**DEPARTMENT OF TRANSPORTATION**

Contract #: 04-0120F4Cty: SF/ALA Rte: 80 PM: 13.2/13.9File #: 69.25B**QUALITY ASSURANCE -- NON-CONFORMANCE REPORT****Location:** Changxing Island, Shanghai, P.R. China**Report No:** NCR-000602**Prime Contractor:** American Bridge/Fluor Enterprises, a JV**Date:** 05-Jan-2010**Submitting Contractor:** Zhenhua Port Machinery Company, Ltd (ZPMC), Changxing Island**NCR #:** ZPMC-0575**Type of problem:**

## NCR PROPOSED RESOLUTION

**Subject:** NCR No. ZPMC-0575

项目名称 Project Name:	美国海湾大桥 SFOBB	部件图号 Drawing No.:	BK1	报告编号 Report No.:	B-CWR102
合同号 Contract No.:	04-0120F4	部件名称 Item Name:	DBG CANTILEVER BOX BRACKET	NDT 报告编号 NDT Report No.:	B787-MT-174
项目编号 Project No.:	ZP06-787

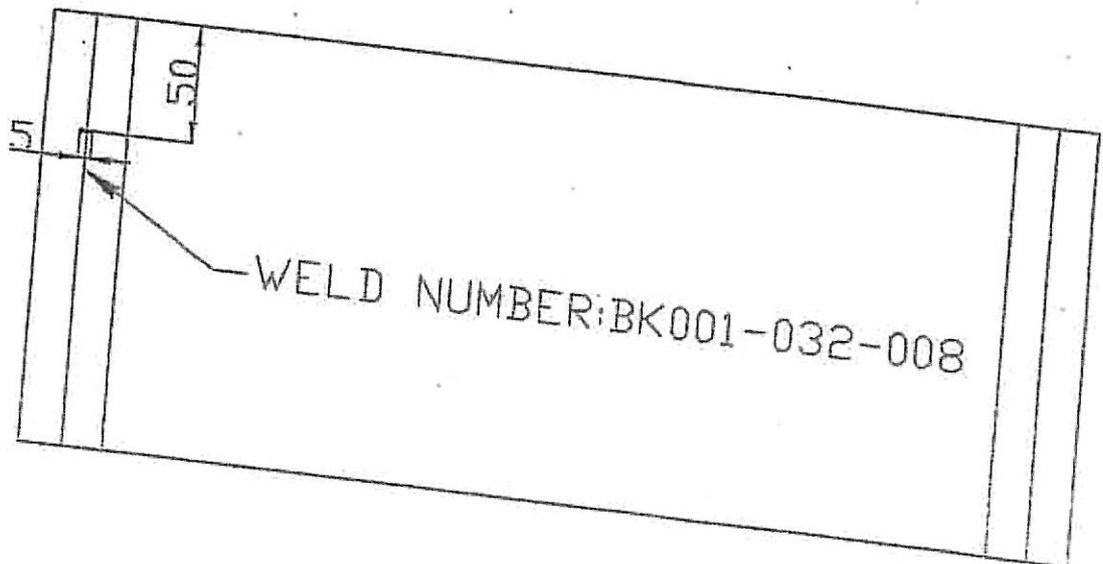
在对BK001-032-008检测时, 发现1处横向裂纹, L1=5mm

One transverse crack was found by use of MT on BK001-032-008.

2. QC and a Lead CWI shall have an approved copy of the CWR in hand prior to the repair.
3. Remove paint  $\geq 25$ mm in all direction of HAZ prior to MT.

6. Prepare excavation in accordance with the New Repair Procedure prior to welding.
7. Before this repair, Verify with VT and MT repair areas are defects free, and also MT shall be performed on the base metal laying abroad cracks to ensure that no cracks were propagated to the base metal. Separate CWR approval is needed if cracks are found in the base metal, and only after this new CWR's approval can continue the repair.

项目名称 Project Name	美国海湾大桥 SFOBB	部件图号 Drawing No	CB202A	报告编号 Report No.	B-WR10060
合同号 Contract No.	04-0120F4	部件名称 Items Name	CB16 STRUT	NDT报告编号 Report No. of NDT	B787-UT-10854
项目编号 Project No.:	ZP06-787

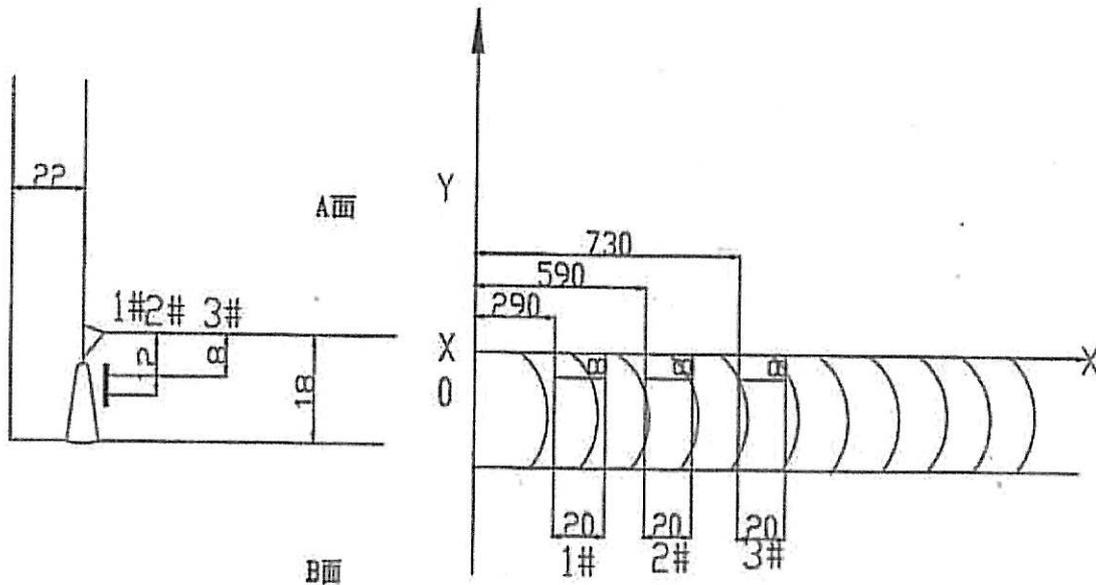
Rejected indication found by ultrasonic inspection is less than the maximum allowance aggregate length.

1. 从缺陷距离端面较近一侧 ( $D \leq 0.65T$ , D为缺陷深度, T为板厚) 采用碳锉或打磨的方法去除焊缝缺陷;
  2. 参照返修焊接工艺规程 (WPS) 准备正确的接头型式, 预热和焊接;
  3. 焊前对修补区域进行VT检测保证缺陷完全被清除;
  4. 将修补区域打磨到与母材或邻近焊缝平齐;
  5. 根据批准的车间图纸检查焊缝.
- 
1. Gouge or grind from nearer side from metal edge ( $D \leq 0.65T$ , "D" is depth of defects, "T" is thickness of metal) to remove all defects;
  2. Follow repair WPS for joint preparation, preheat, and weld deposit;
  3. Verify with VT no defects remain in the weld joint prior to welding;
  4. Grind the repaired area flush with base metal or the adjacent weld;
  5. Check the welds according to the working drawings;

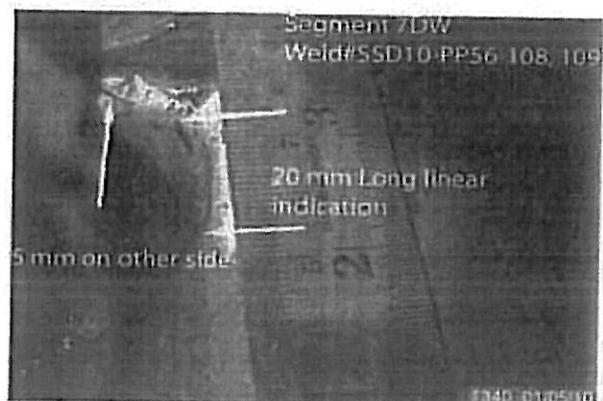
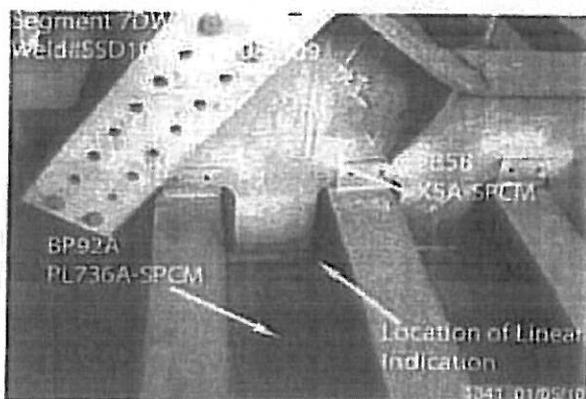
During the Quality Assurance Magnetic Particle Testing (MT) review of welds located on Segment 7DW, this Quality Assurance Inspector (QA) discovered the following issues:

- One (1) Longitudinal linear indication measuring approximately 20mm in length.

- The welds are identified as: SSD10-PP56-108, 109.

- These welds are a Fillet Weld type joining the Bottom Plate (BP92A) to Floor Beam (FB5B) web plate.

- These welds are designated as Seismic Performance Critical Member (SPCM) on the approved drawing (SEGSD10).

项目名称 Project Name:	美国海湾大桥 SFOBB	部件图号 Drawing No.:	SSD10	报告编号 Report No.:	B-CWR1043
合同号 Contract No.:	04-0120F4	部件名称 Item Name:	OBG FLOOR BEAM AND BOTTOM PLAT E	NDT 报告编号 NDT Report No.:	B787-MT-17605
项目编号 Project No.:	ZP06-787

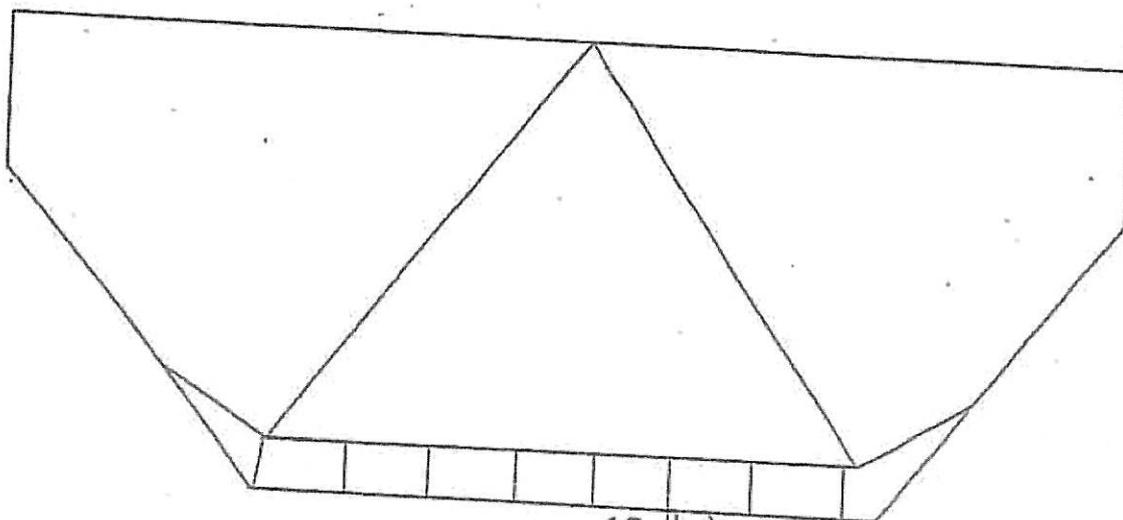
One longitudinal crack was found by use of MT on SSD10-PP56-108.

- 2. QC and a Lead CWI shall have an approved copy of the CWR in hand prior to the repair.
- 3. Remove paint ≥25mm in all direction of HAZ prior to MT.
- 4. Clean the excavation area of all loose debris including MT powder. Preheat to 65° C before removing cracks by grinding, repair area shall extend a minimum of 50mm beyond each end of single crack repairs.

- 6. Prepare excavation in accordance with the New Repair Procedure prior to welding.
- 7. Before this repair, Verify with VT and MT repair areas are defects free, and also MT shall be performed on the base metal laying abroad cracks to ensure that no cracks were propagated to the base metal. Separate CWR approval is needed if cracks are found in the base metal, and only after this new CWR's approval can continue the repair.

项目名称 Project Name:	美国海湾大桥 SFOBB	部件图号 Drawing No.:	SSD11	报告编号 Report No.:	B-CWR1044
合同号 Contract No.:	04-0120F4	部件名称 Item Name:	OBG FLOOR BEAM AND BOTTOM PLAT E 7DW	NDT 报告编号 NDT Report No.:	B787-MT-1760
项目编号 Project No.:	ZP06-7B7

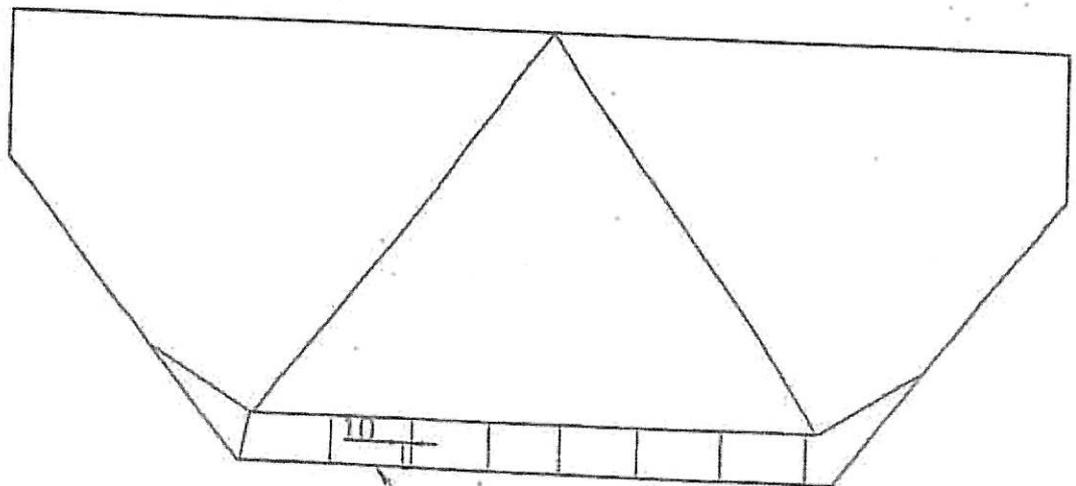
One longitudinal crack was found by use of MT on SSD11-PP57-0B4.

2. QC and a Lead CWI shall have an approved copy of the CWR in hand prior to the repair.
3. Remove paint  $\geq 25$ mm in all direction of HAZ prior to MT.

6. Prepare excavation in accordance with the New Repair Procedure prior to welding.
7. Before this repair, Verify with VT and MT repair areas are defects free, and also MT shall be performed on the base metal laying abroad cracks to ensure that no cracks were propagated to the base metal. Separate CWR approval is needed if cracks are found in the base metal, and only after this new CWR's approval can continue the repair.

项目名称 Project Name:	美国梅湾大桥 SFOBB	部件图号 Drawing No.:	SSD11	报告编号 Report No.:	B-CWR1
合同号 Contract No.:	04-0120F4	部件名称 Item Name:	BCW FLOOR BEAM SPLICE	NDT 报告编号 NDT Report No.:	B787-MT-1
项目编号 Project No.:	ZP06-787

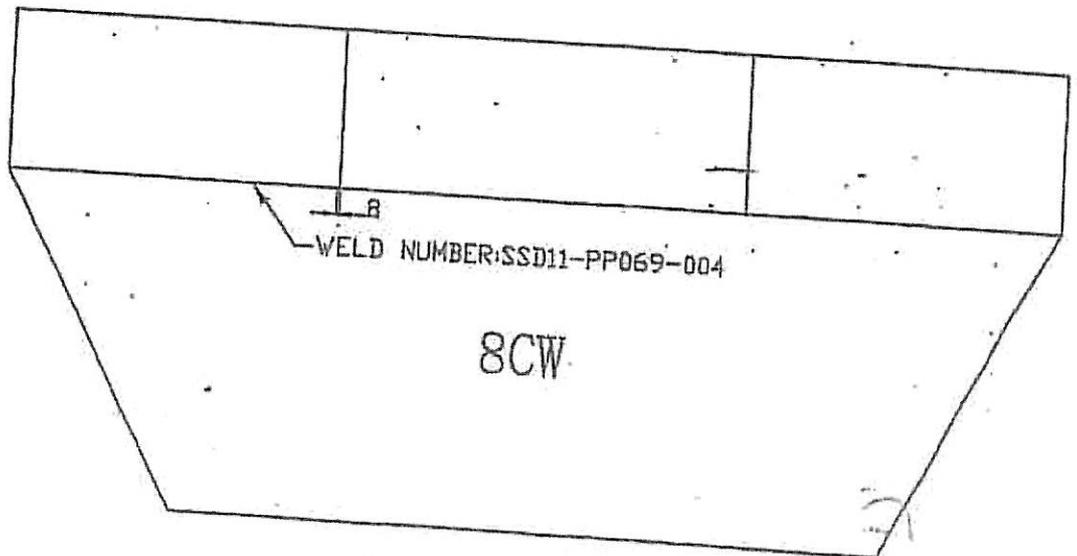
One longitudinal crack was found by use of MT on SSD11-PP69-004.

2. QC and a Lead CWI shall have an approved copy of the CWR in hand prior to the repair.
3. Remove paint  $\geq 25$ mm in all direction of HAZ prior to MT.

6. Prepare excavation in accordance with the New Repair Procedure prior to welding.
7. Before this repair, Verify with VT and MT repair areas are defects free, and also MT shall be performed on the base metal laying abroad cracks to ensure that no cracks were propagated to the base metal. Separate CWR approval is needed if cracks are found in the base metal, and only after this new CWR's approval can continue the repair.

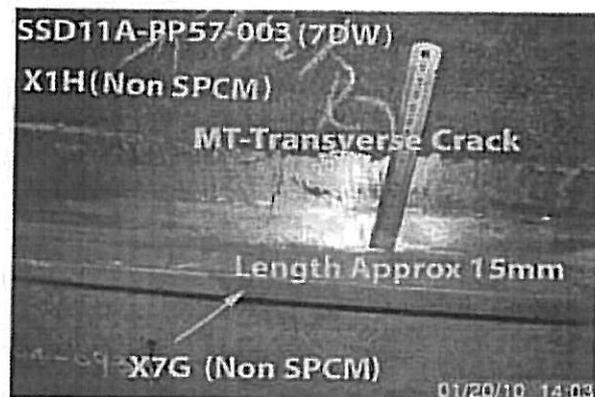
Reference Description: MT Transverse Crack discovered after ZPMC tested and accepted this weld (7DW floorbeam to deck panel diaphragm joint)

项目名称 Project Name:	美国海湾大桥 SFOBB	部件图号 Drawing No.:	SEG039	报告编号 Report No.:	B-CWR1167
合同号 Contract No.:	04-0120F4	部件名称 Item Name:	DBG DECK PLATE SPlice 7BW	NDT 报告编号 NDT Report No.:	B787-MT-18475
项目编号 Project No.:	ZP06-787

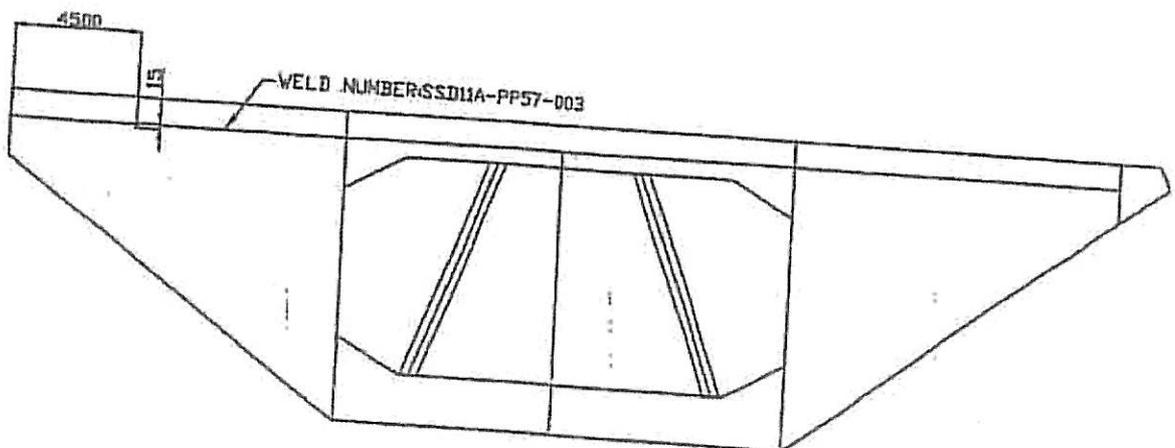
One transverse crack was found by use of MT on SSD11A-PP57-003.

14. 返修后根据图纸进行VT, UT和MT检测, 并按照合同10-1.59 "钢结构" 中的 "检测和试验" 要求进行附加MT检测.
1. QC and a Lead CWI shall be present, direct and supervise all grinding and welding operations during this repair to ensure the repair is per the disposition requirements.

2. QC and a Lead CWI shall have an approved copy of the CWR in hand prior to the repair.
3. Remove paint  $\geq 25$ mm in all direction of HAZ prior to MT.

7. Before this repair, Verify with VT and MT repair areas are defects free, and also MT shall be performed on the base metal laying around cracks to ensure that no cracks were propagated to the base metal. Separate CWI approval is needed if cracks are found in the base metal, and only after this new CWR's approval can continue the repair.

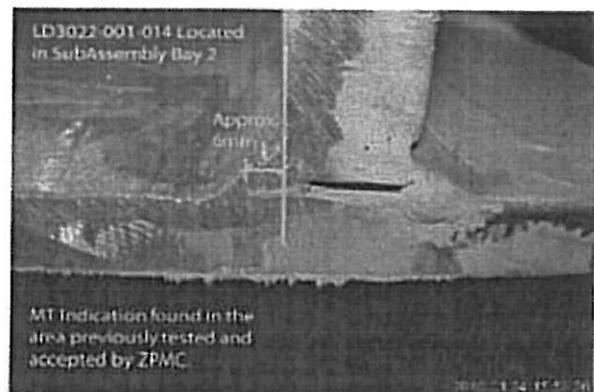
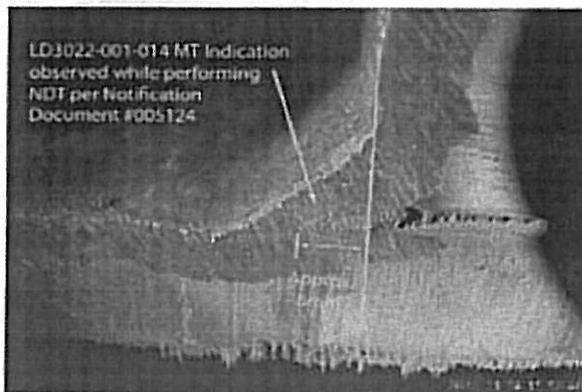
Reference Description: Missed MT Indication by QC for a weld joint on the Lift 12 Longitudinal Shear Plate

项目名称 Project Name:	美国海湾大桥 SFOBB	部件图号 Drawing No.:	LD3022	报告编号 Report No.:	B-CWR1151
合同号 Contract No.:	04-0120F4	部件名称 Item Name:	12 <sup>th</sup> lifting longitudinal diaphragm	NDT 报告编号 NDT Report No.:	B787-MT-17930
项目编号 Project No.:	ZP06-787

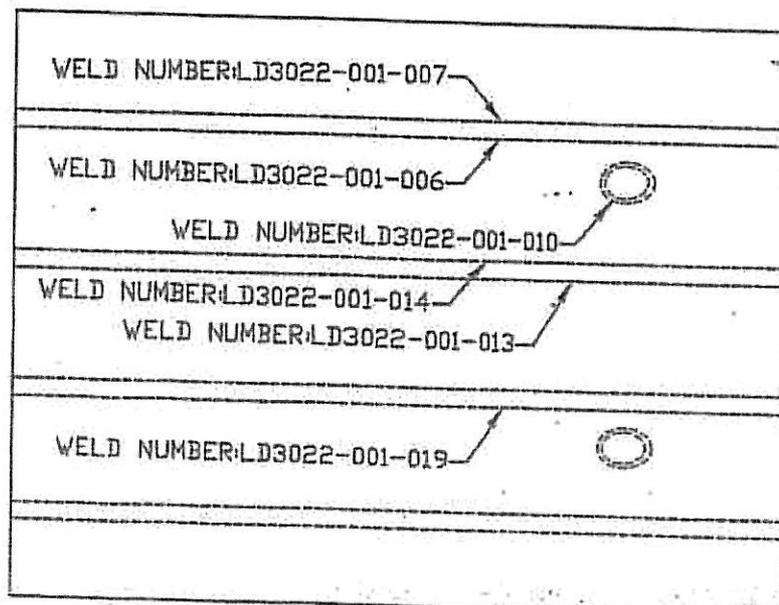
One pore and two transverse cracks were found by use of MT on LD3022-001-006.  
One longitudinal crack and four transverse cracks were found by use of MT on LD3022-001-007.  
One pore and one transverse crack were found by use of MT on LD3022-001-010.  
One pore and two transverse cracks were found by use of MT on LD3022-001-013.  
One longitudinal crack and one transverse crack were found by use of MT on LD3022-001-014.  
One pore and one transverse crack were found by use of MT on LD3022-001-019.

2. QC and a Lead CWI shall have an approved copy of the CWR in hand prior to the repair.
3. Remove paint  $\geq 25$ mm in all direction of HAZ prior to MT.

6. Prepare excavation in accordance with the New Repair Procedure prior to welding.
7. Before this repair, Verify with VT and MT repair areas are defect free, and also MT shall be performed on the base metal laying abroad cracks to ensure that no cracks were propagated to the base metal. Separate CWR approval is needed if cracks are found in the base metal, and only after this new CWR's approval can continue the repair.
